MIL-PRF-55339/14  
AMENDMENT 1  
28 February 1979

PERFORMANCE SPECIFICATION

ADAPTER, CONNECTOR, COAXIAL, RADIO FREQUENCY,  
(WITHIN SERIES BNC), CLASS 2, RIGHT ANGLE PLUG

This amendment forms a part of performance specification sheet MIL-PRF-55339/14, dated 6 May 1975, and is approved for use by all Departments and agencies of the Department of Defense.

FIGURE 2, delete and substitute:

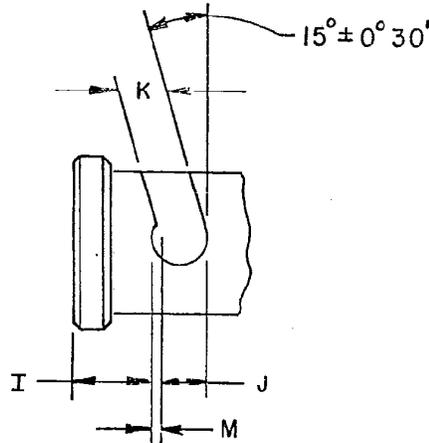
FIGURE 2, maximum column: Add dimension E ".230 (5.84)", dimension L ".040 (1.02)", and dimension P ".228 (5.79)".
